PCN 客户确认通知单
PCN customer confirmation Notice

PCN NO#: 14111001

| 产品型号 Part No. | 28L0138-*0R-10 (* = 0,1,2,3,4,5,6,7,8,9,A) | 提出日期 Submission date | 2014-11-10 |

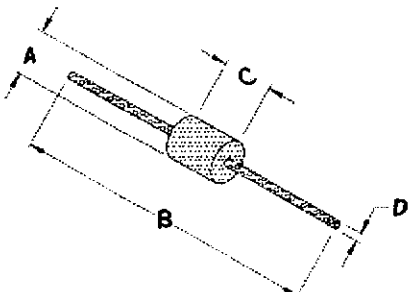
| 变更内容 Change content | Change the dimension "B" from 59.00±1.57mm to 62.00±1.50mm to meet the tape & reel. | | |

| | "B" | Before(mm) | After(mm) |
| | Maximum | 60.57 | 63.50 |
| | Nominal | 59.00 | 62.00 |
| | Minimum | 57.43 | 60.50 |
